Access Compliance Report

(Curb Ramps)

Intersection ID: 50867	Main Street: REAMES_RD	Cross Street: BROOKLINE_RIDGE_DR	Location: S
ADA ID: F9BCB7F9E8E3	Ramp Type: Perp	Initial Pass/Fail: Fail	Overall Compliance: No
Severity Score: 8.75			
Codes/Mitigation Info/Possible Solution		Field Measurements/Component Compliance

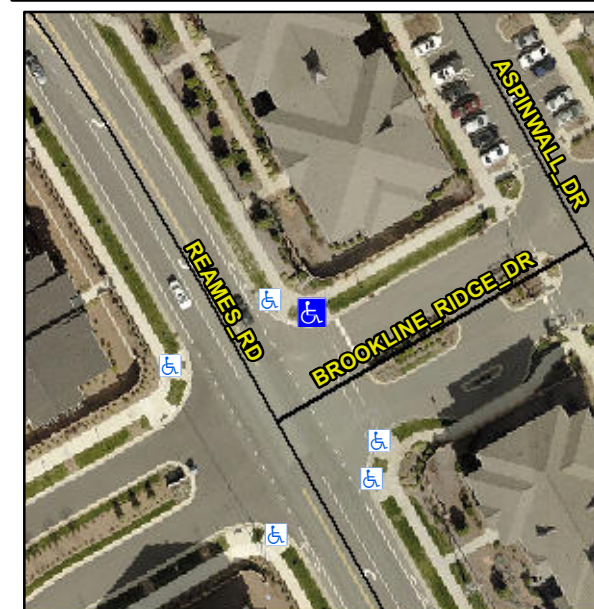
Not Found, R304.5.1

Compliance	Description	Data	Compliance	Description	Data
N/A	Ramp Length (in)	96.5	Yes	Ramp Slope (%)	7.3
No	Ramp Width (in)	47.0	Yes	Ramp XSlope (%)	0.7
N/A	Flare Type LT	N/A	N/A	Flare Type RT	N/A
N/A	Flare Slope LT (%)	N/A	N/A	Flare Slope RT (%)	N/A
N/A	Flare Traversable LT?	N/A	N/A	Flare Traversable RT?	N/A
N/A	Landing Length (in)	N/A	N/A	DWS Provided?	N/A
N/A	Landing Width (in)	N/A	N/A	DWS Contrast?	N/A
N/A	Landing Slope (%)	N/A	N/A	DWS Length (in)	N/A
N/A	Landing X Slope (%)	N/A	N/A	DWS Full Width?	N/A
N/A	Landing Curb? (Y/N)	N/A	N/A	DWS Offset (in)	N/A
N/A	Shared Landing?	N/A			
N/A	Gutter Ponding?	N/A	N/A	Gutter Slope (%)	N/A
N/A	Gutter Lip Ht (in)	N/A	N/A	Gutter X Slope (%)	N/A
N/A	Painted X Walk1?	Yes	N/A	Painted X Walk2?	N/A
	X Walk 1 Direction	To S		X Walk 2 Direction	N/A
N/A	X Walk 1 Width (in)	60.0	N/A	X Walk 2 Width (in)	N/A
	X Walk 1 Slope (%)	1.0		X Walk 2 Slope (%)	N/A
	X Walk 1 X Slope (%)	0.3		X Walk 2 X Slope (%)	N/A

Remove & Replace Entire Ramp.
